Technical Service Bulletin

66 Rear spoiler is inoperative

66 22 85 2065220/2 March 10, 2022. Supersedes Technical Service Bulletin Group 66 number 21-79 dated December 7, 2021 for reasons listed below.

Figure 2. Cutaway view of the motor brush to commutator area.

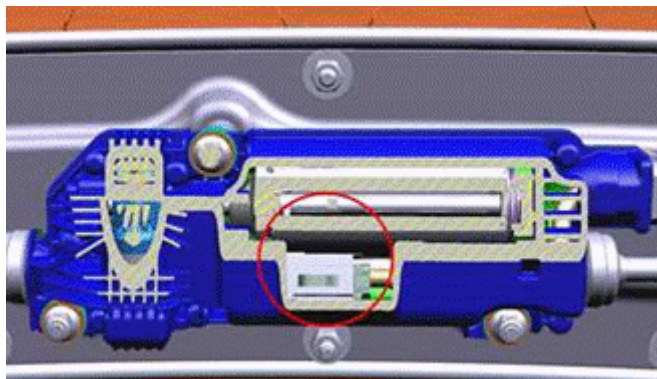
Due to insufficient pressure of the carbon brushes to the motor commutator in the spoiler drive motor a loss of contact may occur and cause intermittent or permanent loss of spoiler operation.

Figure 2 shows the spoiler drive motor area of brush to commutator contact.

The rear spoiler drive motor has been redesigned. An increase in brush to commutator pressure has been implemented in production.

Figure 3. Rear spoiler drive assembly.

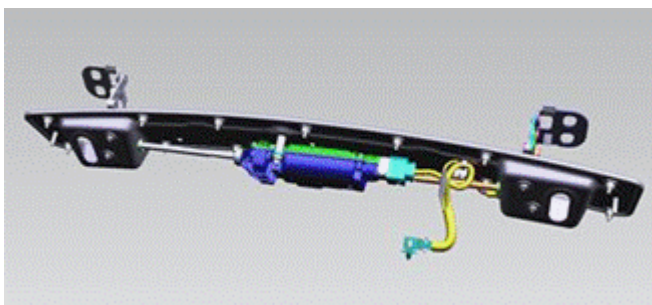
1. Should the vehicle exhibit the symptom profile described in this TSB, replace the rear spoiler drive unit. Figure 3 shows the rear spoiler drive assembly.
